Collected comments on Section 3 of draft standard D1

Figure 3-1: Structure of SDE_PDU

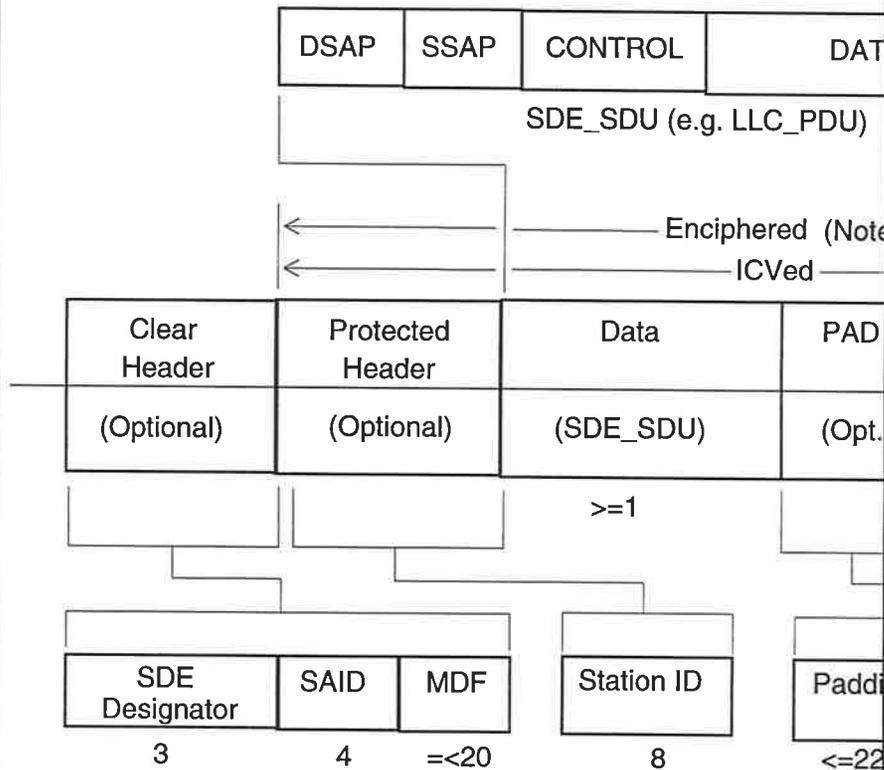
3.1.1.3	CHRIS ZEGELIN		THE PICTURE IS INCONSISTENT WITH THE WEP ALGORITHM SHOWN LATER AND USES TERMS THAT ARE NOT DEFINED. FURTHER THERE ARE OPTIONS SHOWN WITH NO DEFINITION OF WHEN THEY ARE USED. THIS WHOLE DRAWING SHOULD BE DELETED FROM THE TEXT TILL ALL THE INCONSISTENCIES WITH THE SECURITY PROVISIONS ARE WORKED OUT.	THERE IS INSUFFICIENT CLEAR DETAIL TO IMPLEMENT THE SECURITY PROVISIONS. THEY CURRENTLY CONFUSE MORE THAN HELP.

3.1.1.3	A. Bolea	E	reference to section 2.4 should be to section 2.9 (or figure 2-11)	
3.1.1.3	Glen Sherwood	E	Error in Figure 3-1: the SDE_SDU right bracket should point back to the right edge of the Data field.	SDE_SDU is the data in the SDE_PDU frame.

The IEEE 802.10 SDE [2] describes five parts to the SDE_PDU: Clear Header, Protected Header, Data, Pad, and Integrity Check Value (ICV).

Only the data is required, all other parts are optional to the particular implementation and the security services provided by the application of the SDE. All implementations of 802.11 shall provide for encipherment of data using the default algorithm(s). The default encipherment algorithm(s) are for further study.

The 802.11 document should not attempt to duplicate the contents of other standards documents, thus I have removed the excerpts from 802.10 and left the relevant references.
